ADDENDUM NO. 1

8TH STREET WATER & SEWER RELOCATIONS (MOBERLY LANE TO INTERSTATE 49)

City of Bentonville, Arkansas
AHTD Project No. 090976
Federal Aid Project HHP2-3314(1)
USI Project No. 1009022

**24" WATERLINE TEE,
VALVE, & ANCHORING
DETAIL**

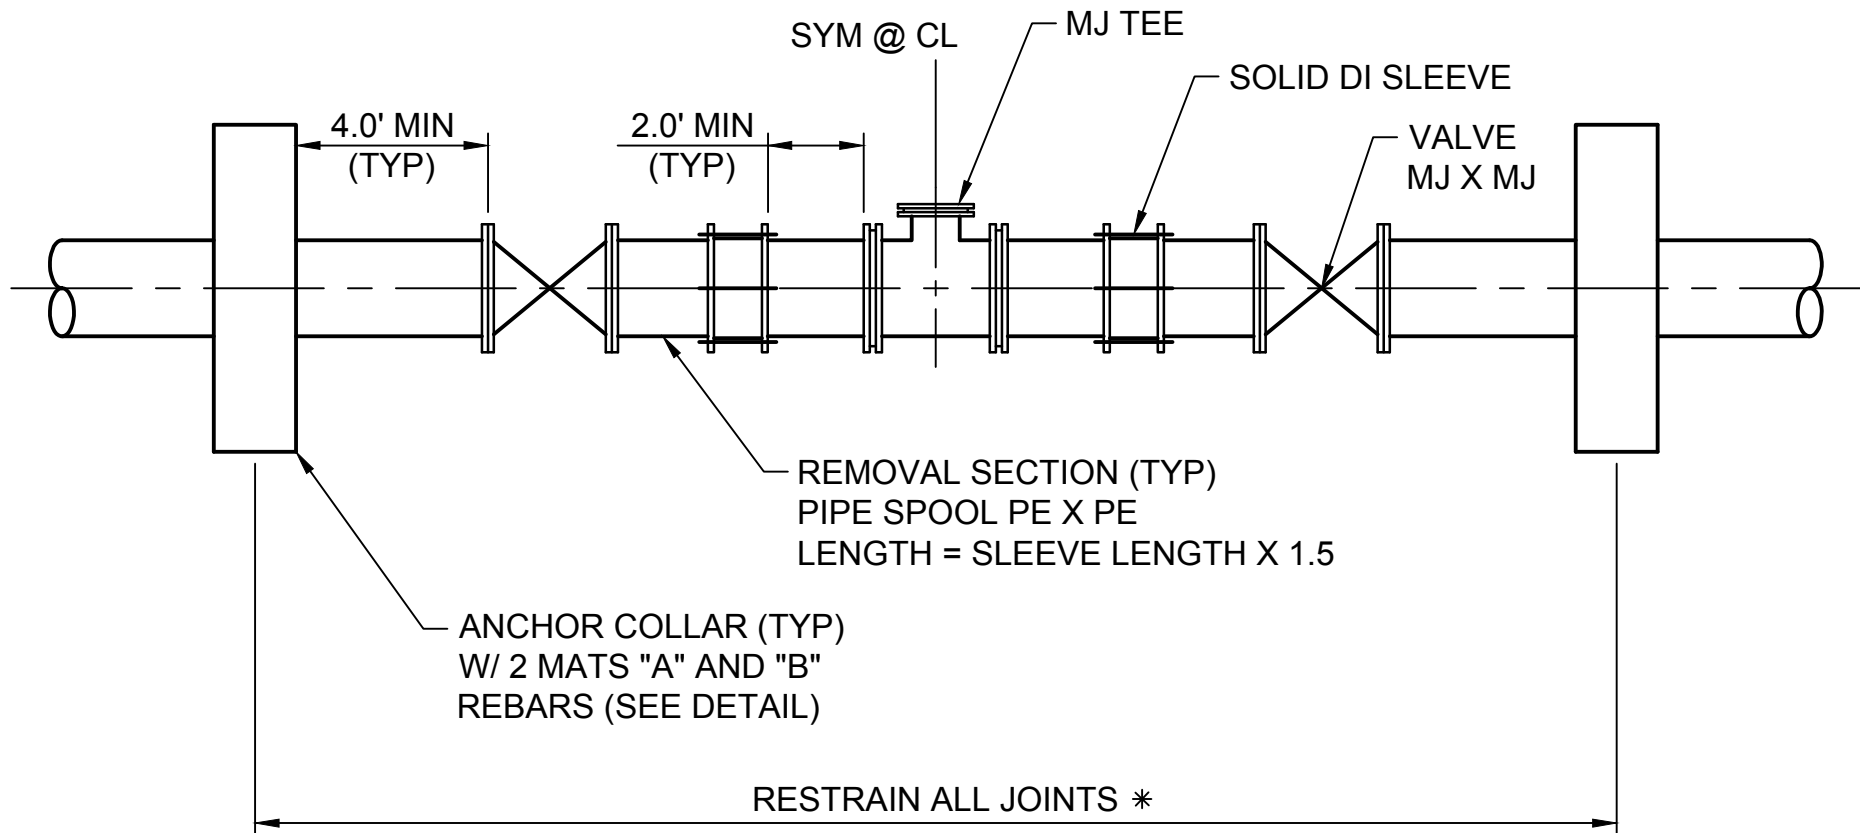
A detail for 24” tee and valves is attached to this addendum to clarify the City’s standard detail’s application to the specific scenarios in this project.

* IF ONLY ONE VALVE AT TEE INSTALL BOTH ANCHOR COLLARS AND RESTRAIN BETWEEN AS SHOWN.
ADJUST VALVE STATIONING TO MATCH LOCATIONS SHOWN ON DETAIL.
